**CITY OF CARMEL-BY-THE-SEA
PLANNING COMMISSION
REGULAR MEETING AGENDA**

November 12, 2014
Wednesday
Tour – 2:30 p.m.
Meeting – 4:00 p.m.

Dennis Levett
Monte Verde 3 NE of 4th
Blk: 32, Lot: 16
APN: 010-222-007</p> | <p>Consideration of Final Design Study (DS 14-72) and associated Coastal Development Permit application for the construction of a new residence located in the Single-Family Residential (R-1) Zoning District</p> |

E2.1
SHEET 454

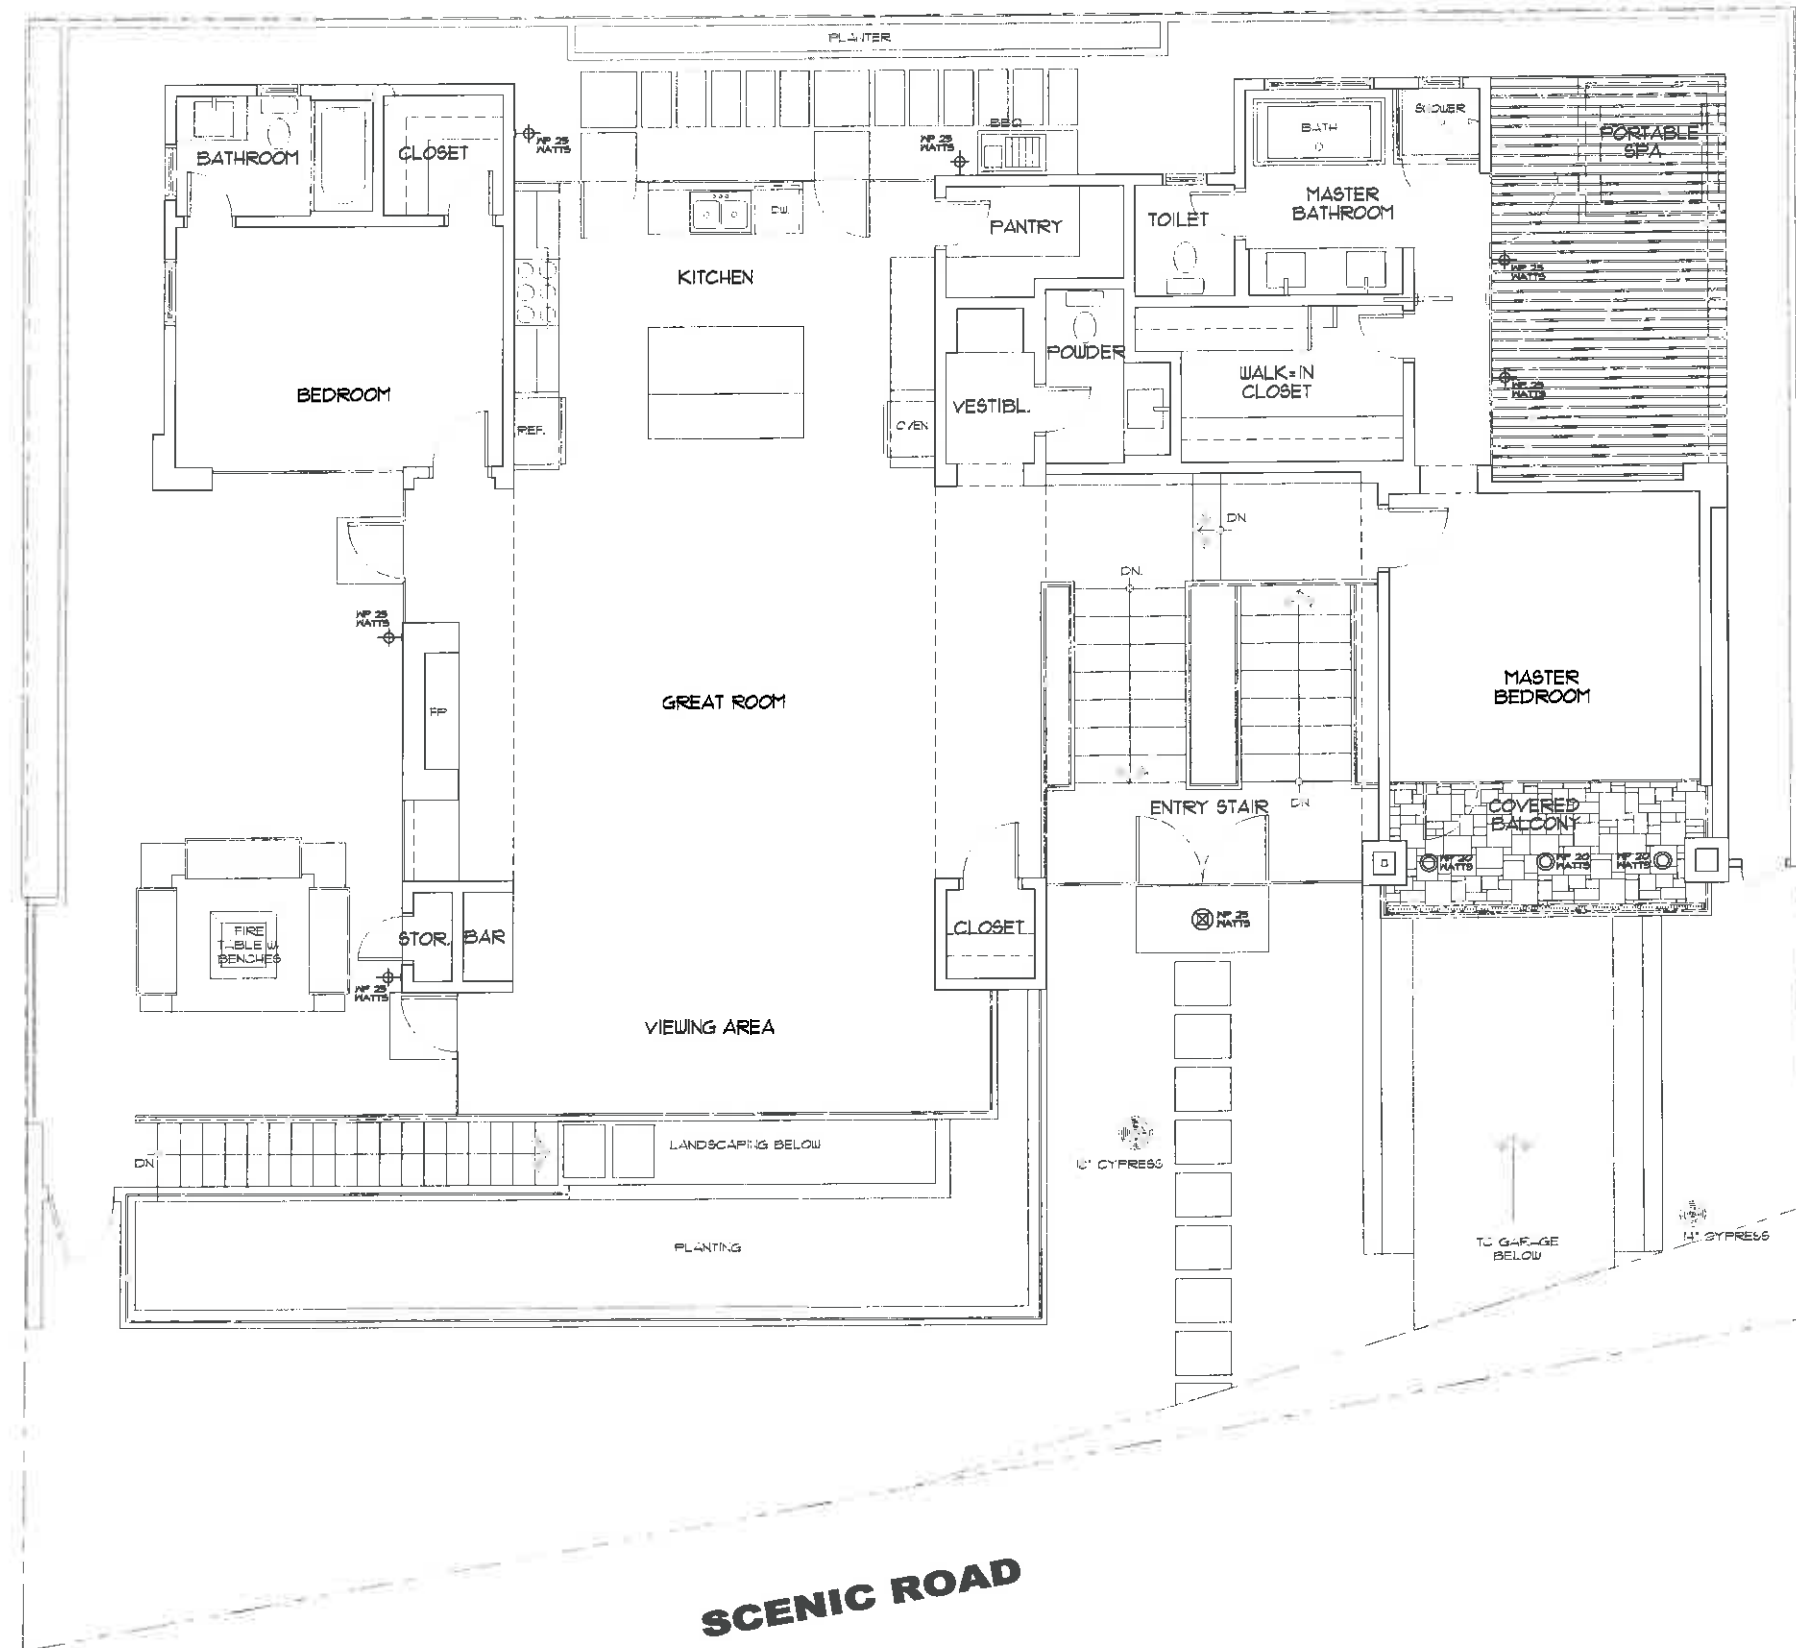
Exterior Lighting: The location, wattage, and style of the wall-mounted light fixtures are depicted on the lighting plan shown on Sheet E-2.1 of the plan set. The plan set notes that the wattage will be 25 watts maximum for the wall mounted fixtures; however, no bulb type or lumen level is noted. This should be clarified by the applicant and noted on the construction plan set. A condition of approval has been drafted to address this requirement.

With regard to landscape lighting, Municipal Code Section 15.36.070.B.2 states that Landscape lighting shall not exceed 18 inches above the ground nor more than 15 watts (incandescent equivalent; i.e., approximately 225 lumens) per fixture and shall be spaced no closer than 10 feet apart. A landscape lighting plan is shown on Sheet L-2 of the plan set. The plan indicates that the light fixtures meet the wattage requirements; however, the lumen level and bulb type is not identified and some of the fixtures are spaced closer than 10 feet from each other. A condition has been drafted to address these issues.
